April 15, 2009  
NND-09-0076

Subject: Virgil C. Summer Nuclear Station (VCSNS) Units 2 and 3 Combined License Application (COLA) - Docket Numbers 52-027 and 52-028 Response to NRC Request for Additional Information (RAI) Letter No. 033

**NRC RAI Letter No. 033 Dated February 12, 2009**

**SRP Section: 2.5.1 – Basic Geologic and Seismic Information**

**Figure 2.5.1-209 Site Vicinity Gravity and Magnetic Profiles**

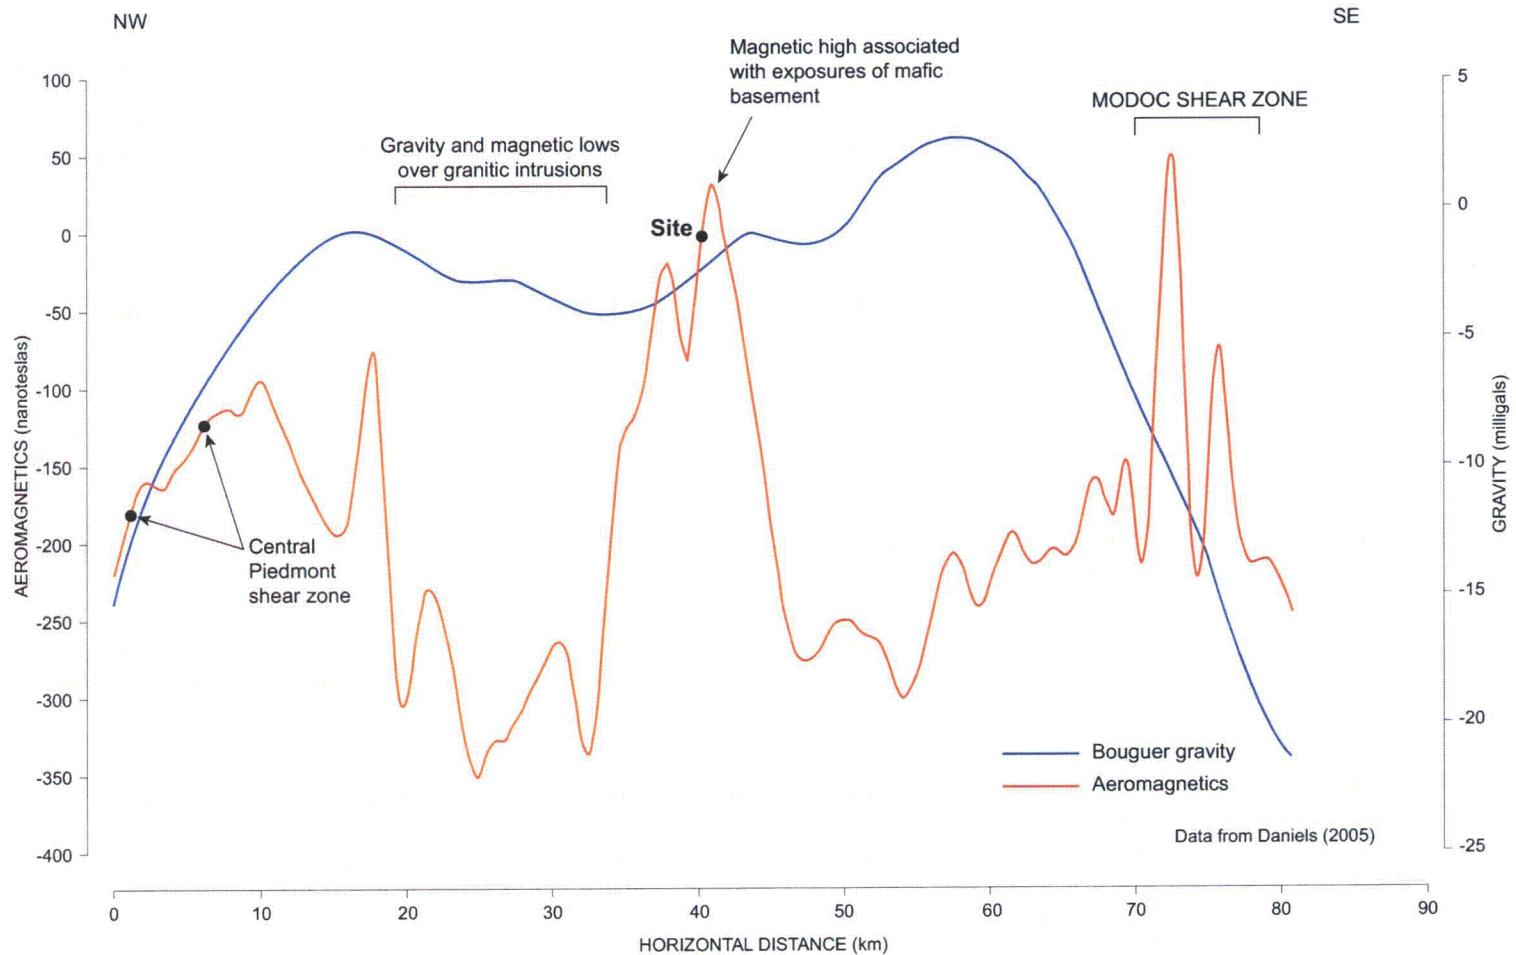
FSAR Figure 2.5.1-209 illustrates site vicinity gravity and magnetic profiles and discusses the information reflected in these profiles in Sections 2.5.1.1.2.3.1 (pg 2.5.1-15) and 2.5.1.1.2.3.2 (pg 2.5.1-17) with reference to the Central Piedmont and Modoc shear zones. However, neither the Central Piedmont shear zone (CPSZ) nor the Summer site is located in the profiles to enable correlation of gravity and magnetic anomalies in the site vicinity with regional geologic structures. Furthermore, as illustrated in the profiles of Figure 2.5.1-209, the relatively short wavelength magnetic high near 20 km (12.43 mi), which appears to correspond with a gravity high, and the magnetic low from about 50-70 km (31.07-43.5 mi), which corresponds with a gravity high, are not explained in relation to regional features which may cause these anomalies.

It is also not clearly stated in FSAR Sections 2.5.1.1.2.3.1 (pg 2.5.1-15) and 2.5.1.1.2.3.2 (pg 2.5.1-17) whether the site vicinity gravity and magnetic profiles represent data collected at that scale or are extrapolated from regional gravity and magnetics data. However, the reference cited in Figure 2.5.1-209 (Daniels, 2005) would seem to indicate that these site vicinity data are extracted from gravity and magnetic maps produced for the State of South Carolina and, therefore, the data is at a scale less than the regional scale but greater than the site vicinity scale.

In order for the staff to determine the adequacy of the geologic interpretations based on site vicinity gravity and magnetics data provided in the FSAR, please locate the site and the CPSZ on Figure 2.5.1-209 and discuss the significance of these two magnetic anomalies as they may relate to the gravity anomalies and geologic structures or lithologies in the site vicinity. Please also clarify whether the site vicinity gravity and magnetic profiles represent data collected at that scale or are extrapolated from regional gravity and magnetics data or a statewide database. Finally, please summarize any pertinent points discussed by Daniels (2005) related to the anomalies as they may bear on geologic structures in the site vicinity.

The Central Piedmont shear zone in the site vicinity marks the boundary between the rocks of the Inner Piedmont and those of the Carolina Zone, and includes faults that define the Whitmire Reentrant (FSAR Figure 2.5.1-212). The map pattern of the Whitmire Reentrant indicates that the thrust fault that defines the boundary is a

relatively flat-lying feature that exposes Inner Piedmont rocks (Cat Square terrane) in a window through the Carolina Zone (Charlotte terrane). These relationships imply that the Carolina Zone, at least in the vicinity of the Whitmire Reentrant, is thin and underlain at relatively shallow depths by Inner Piedmont rocks. The location of the magnetic and gravity profiles illustrated in FSAR Figure 2.5.1-209 transects the Whitmire Reentrant in a small portion of its northeastern extent so that the bounding fault is intersected in two locations a relatively short distance apart. FSAR Figure 2.5.1-209 (Site Vicinity Gravity and Magnetic Profiles) will be revised to show the location of the Central Piedmont shear zone, as defined by the boundaries of the Whitmire Reentrant. In addition, the location of the site and site area boundaries will also be annotated.

The FSAR Figure 2.5.1-209 will be replaced with the attached revised Figure 2.5.1-209 (Attachment 1 to this response).

Figure 2.5.1-212 50-Mile Tectonic Features Map

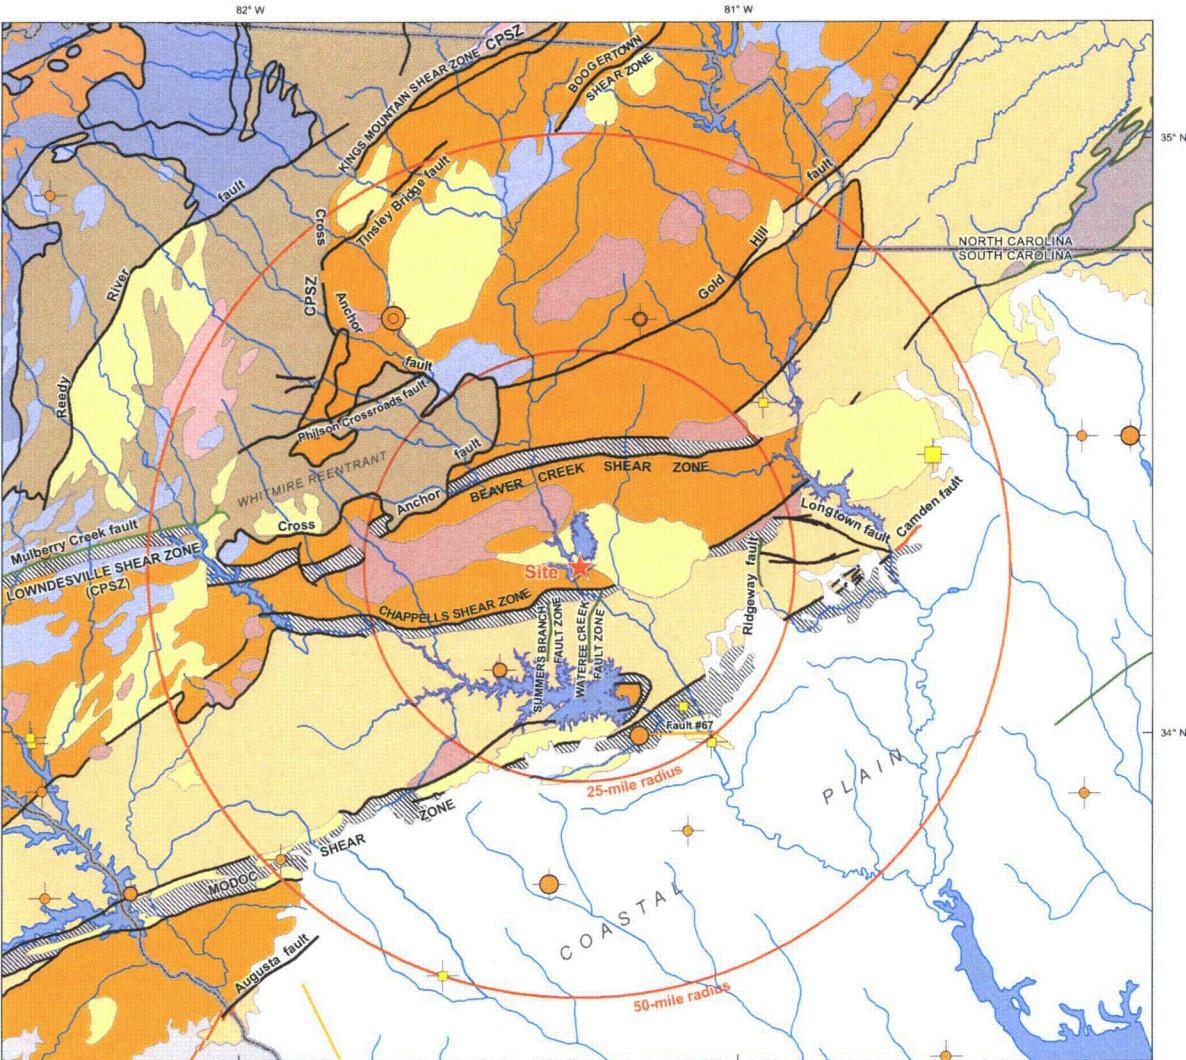
FSAR Section 2.5.1.1.2.4.2 (pg 2.5.1-24) discusses the Mulberry Creek fault, indicating it is Mesozoic in age based on an association with other similar silicified breccias described by West (1998), although the legend symbol shown in FSAR Figure 2.5.1-212 indicates it is Paleozoic in age. However, Nystrom (2006) discussed field occurrence of silicified breccias in the site region and suggested that they may occur along faults exhibiting late Cenozoic movement in the Eastern Piedmont fault zone. In addition, there is no explanation in the figure legend for the “diagonal line” symbol shown on the map which appears to designate shear zones in some cases (e.g., the Modoc shear zone) but not in others (e.g., the Kings Mountain and Boogertown shear zones).

In order for the staff to completely understand the geologic setting of the Summer site in relation to regional tectonic structures, please qualify the age of the Mulberry Creek fault and summarize the logic presented by West (1998) that silicified breccias are indicative of Mesozoic age fault displacements in light of the interpretation by Nystrom (2006) that late Cenozoic movement may have occurred along some structures in the site region which are marked by silicified breccias. Please also explain the meaning and use of the “diagonal line” symbol in Figure 2.5.1-212.

Based on available data, the Mulberry Creek fault is assessed to be Mesozoic in age. As such, FSAR Figure 2.5.1-212 will be revised to show the Mulberry Creek fault as a Mesozoic structure. The use of the “plain line” symbol in FSAR Figure 2.5.1-212 indicates shear zones, fault zones, and faults that are mapped in their original source reference with width equal to or less than the plain line width shown in FSAR Figure 2.5.1-212. The use of the “diagonal line” symbol in FSAR Figure 2.5.1-212 indicates shear zones, fault zones, or faults that are mapped in their original source reference as having width greater than the plain line width in FSAR Figure 2.5.1-212.

1. The FSAR Figure 2.5.1-212 will be replaced with the attached revised Figure 2.5.1-212 (Attachment 2 to this response) to show the Mulberry Creek fault as a Mesozoic structure.

Figure 2.5.1-211 Site Region Tectonic Features

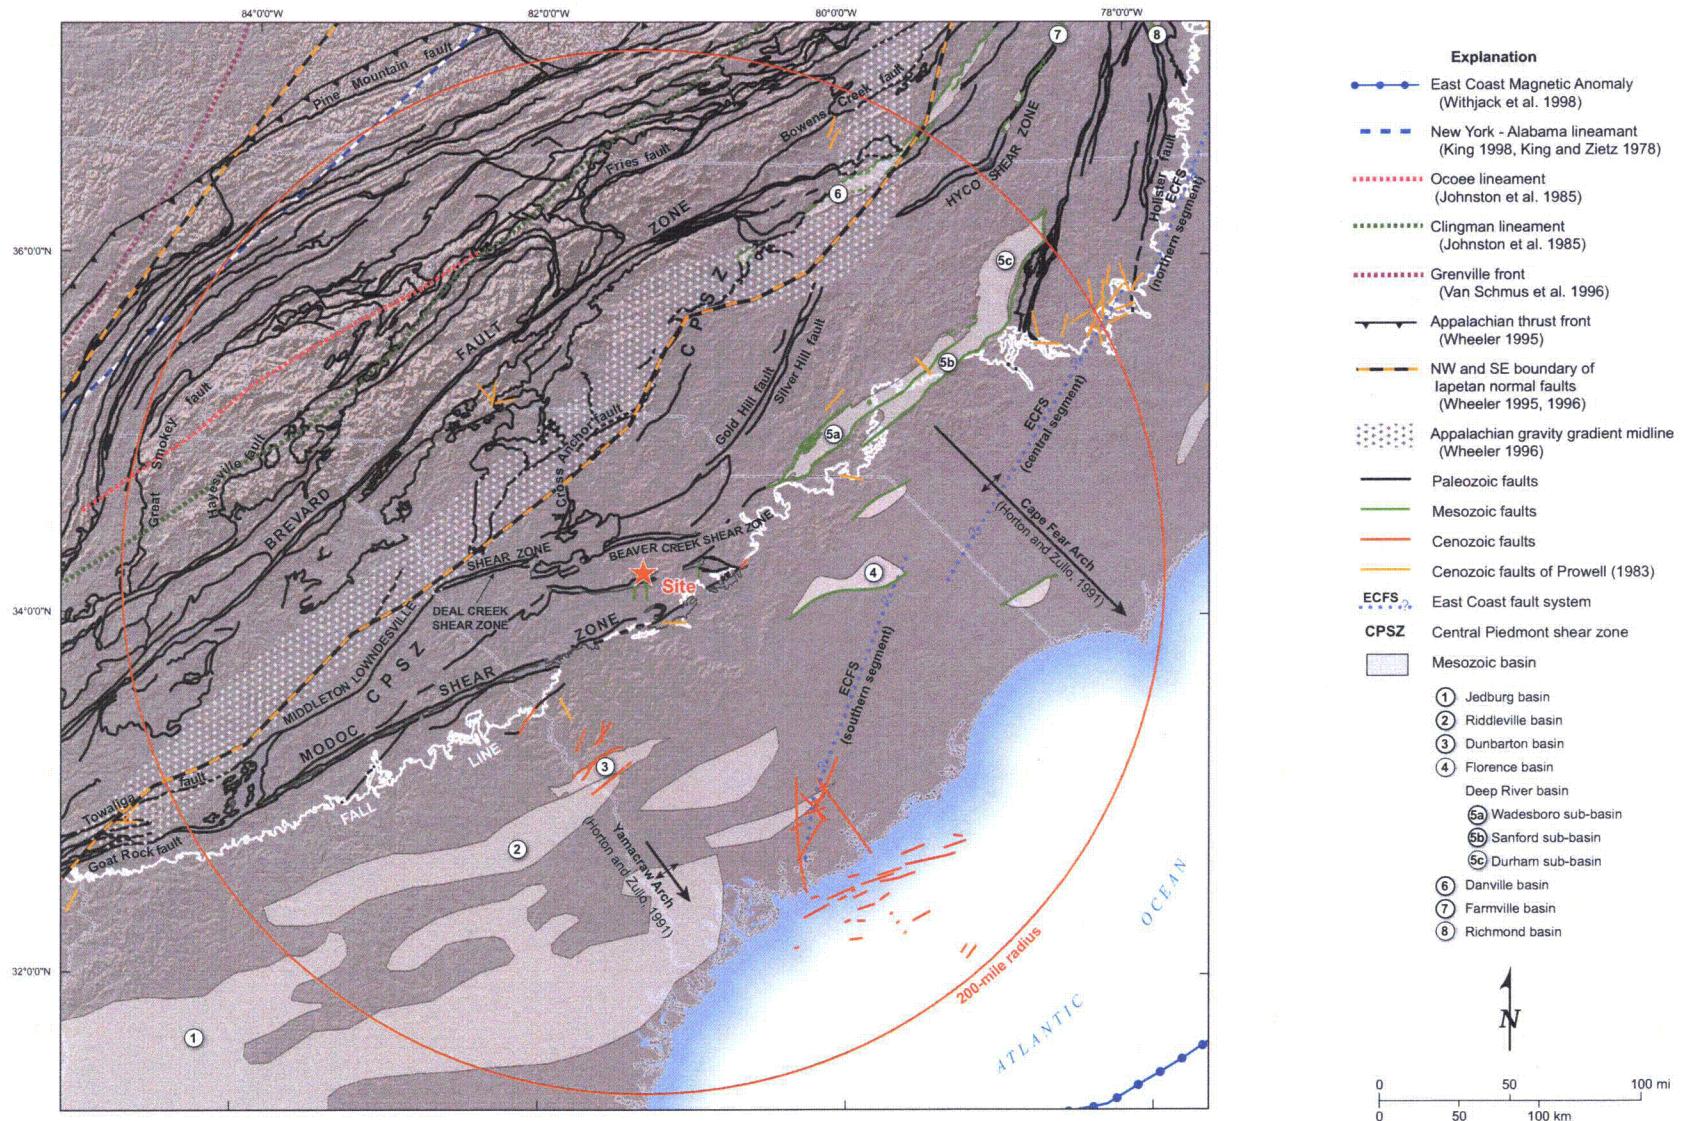
FSAR Section 2.5.1.1.2.4.3 (pg 2.5.1-26) discusses arches and embayments but does not show the location of the Yamacraw Arch on Figure 2.5.1-211 on which the Cape Fear Arch is located. This section states that late Cretaceous through Pleistocene (i.e., as young as 1.8 my to 10,000 yrs in age) differential tectonic movement is indicated by these features, although Crone and Wheeler (2000) label them as Class C features. Furthermore, FSAR Section 2.5.1.1.2.4.4 (pg 2.5.1-29), mentions the Cape Fear Arch, but not the Yamacraw, in relation to potential regional Quaternary tectonic structures.

In order for the staff to assess the hazard potential for these two arches, please locate the Yamacraw Arch on Figure 2.5.1-211 and include a discussion of this arch in FSAR Section 2.5.1.1.2.4.4, as was done for the Cape Fear Arch. Please also refer to primary sources of data which render the conclusions about these features plausible rather than relying on the compiled information presented by Crone and Wheeler (2000).

The basement surface on which Coastal Plain sediments were deposited is not a simple planar platform. Instead, it is characterized by broad structural upwarps (arches) that separate depositional basins (embayments) (Horton and Zullo 1991) (FSAR Reference 2.5.1-261). The hinge lines of these upwarps are aligned roughly perpendicular to the coastline. Two of these upwarps, the Cape Fear and Yamacraw arches, are located within the site region. The Cape Fear arch is located near the South Carolina-North Carolina border (FSAR Figure 2.5.1-211). The Yamacraw Arch is located near the South Carolina-Georgia border and will be added to FSAR Figure 2.5.1-211.

3. The FSAR Figure 2.5.1-211 will be replaced with the attached revised Figure 2.5.1-211 to show the location of the Yamacraw Arch.

Figure 1. Local Charleston Faults and Seismicity

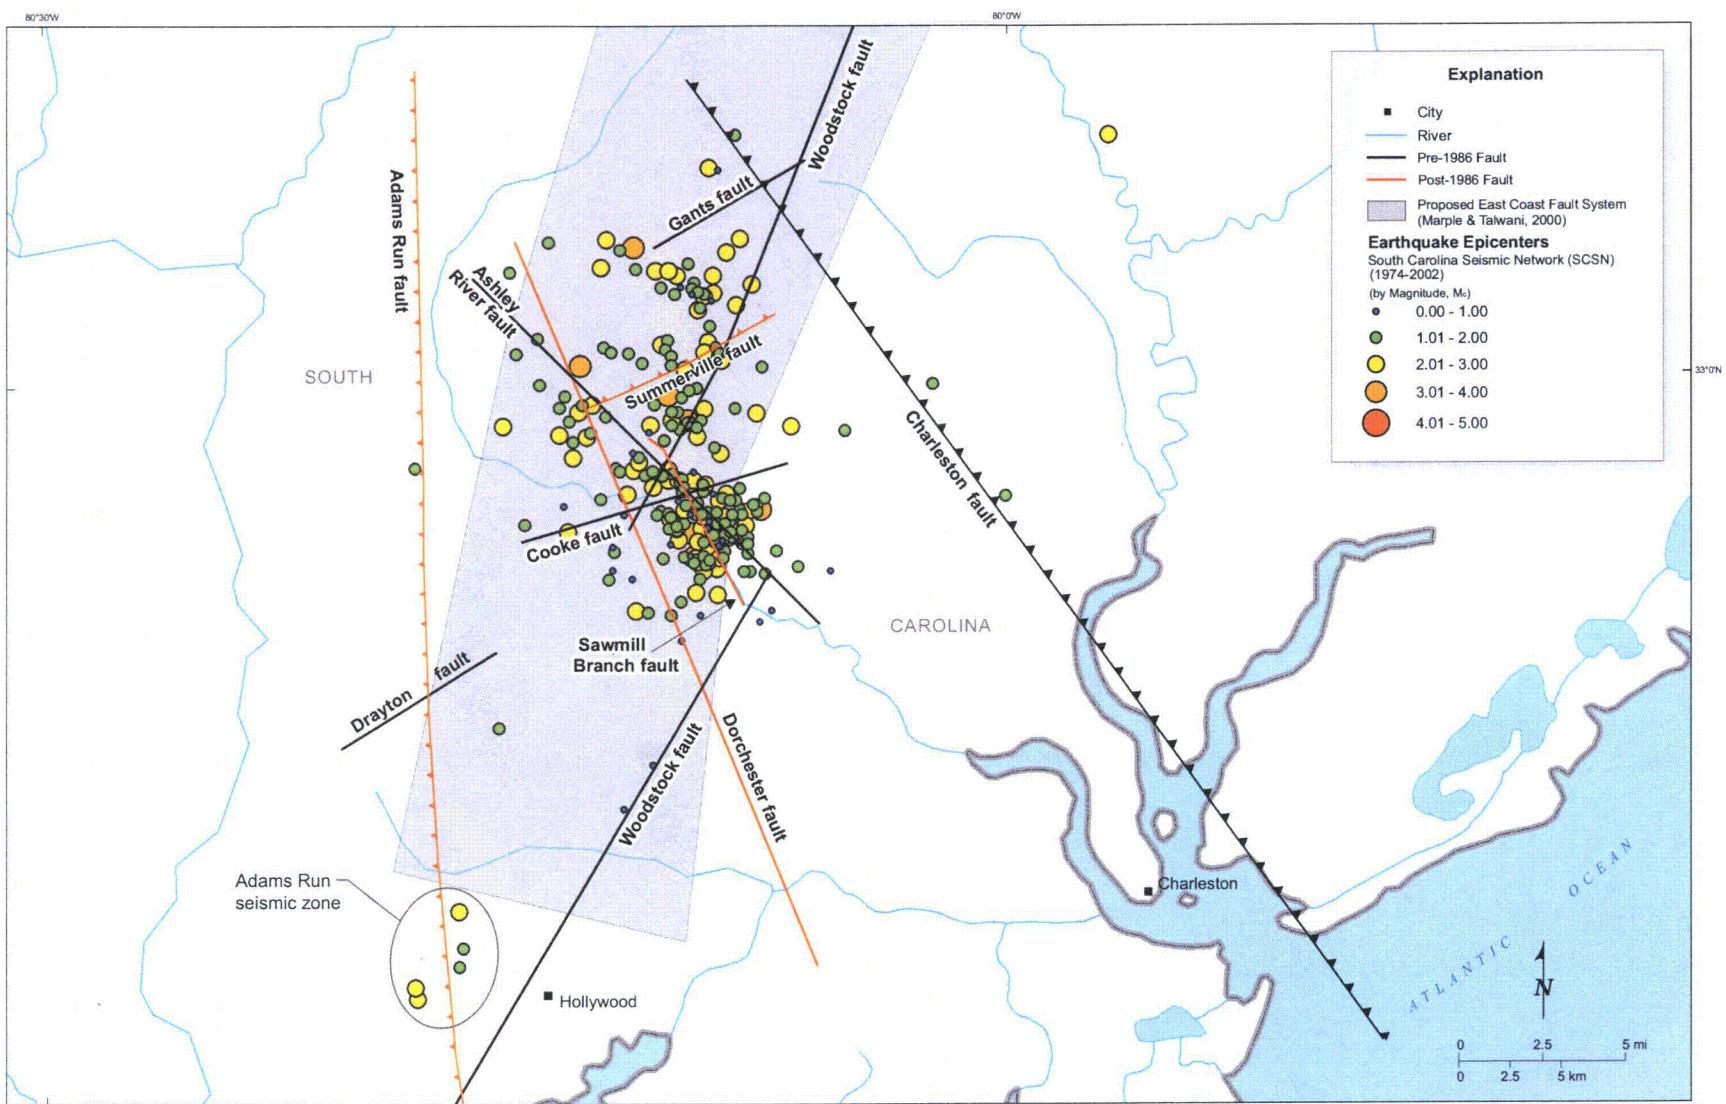
In order for the staff to assess the hazard potential of the Sawmill Branch fault, please provide a corrected figure to illustrate location, orientation, and cross-cutting character of this fault. Please also discuss the proposed Dorchester fault, locate this structure on the appropriate map, and clarify the interpreted relationships between the Sawmill Branch, Ashley River, Woodstock, and Dorchester faults taking into account information presented in the recent literature.

The Dorchester fault is proposed by Bartholomew and Rich (2007) (Reference 1) as a near-vertical, northwest-striking, reverse-oblique (right-lateral) fault located in the general vicinity of the Ashley River and Sawmill Branch faults (Figure 1). This proposed fault is shown in Figure 1, but is not shown on FSAR Figures 2.5.1-218 and 2.5.1-219 because of its highly speculative nature. As proposed, the Dorchester fault is a subsurface feature that extends from a depth of about 8 kilometers below the ground surface downward to a depth between 13 and 25 kilometers. The existence of this proposed fault is not based on direct evidence, but rather is inferred based on the analysis of: (1) cracks in the walls of colonial Fort Dorchester, (2) local and regional stress orientations including borehole breakouts, and (3) fault plane solutions from local microseismicity. There is no direct geologic or geomorphic evidence for the Dorchester fault. However, Bartholomew and Rich (2007) (Reference 1) suggest that local geomorphology is consistent with the location of the proposed Dorchester fault and a fault length of approximately 43 kilometers. Based on the lack of direct evidence presented by Bartholomew and Rich (2007) (Reference 1), the existence of the Dorchester fault is assessed to be questionable.

FSAR Figures 2.5.1-218 and 2.5.1-219 show the Sawmill Branch and Ashley River faults intersecting at a low angle in an apparent crosscutting relationship. Likewise, Figure 1 shows the Dorchester fault intersecting the Ashley River and Woodstock faults. The locations of proposed faults in the Charleston 1886 meizoseismal area, however, are poorly constrained by available data. Moreover, the locations of the Ashley River, Sawmill Branch, Woodstock, and Dorchester faults are based on coarse-scale location maps from publications authored by separate research groups. The Ashley River fault is based on mapping presented at roughly 1:700,000-scale in Weems and Lewis's (2002) (FSAR Reference 2.5.1-399) Figure 14. The Sawmill Branch and Woodstock faults are based on mapping presented at roughly 1:400,000-scale in Talwani and Katuna's (2004) (FSAR Reference 2.5.1-385) Figure 2. The Dorchester fault is based on mapping presented at roughly 1:500,000-scale in Bartholomew and Rich's (2007) (Reference 1) Figure 2. Based on the highly speculative nature of these faults, interpreting relationships between them is questionable. As mapped, however, the proposed Sawmill Branch, Ashley River, and Dorchester faults are located in the apparent left-stepover separating the southern and northern Woodstock faults (Attachment 4).
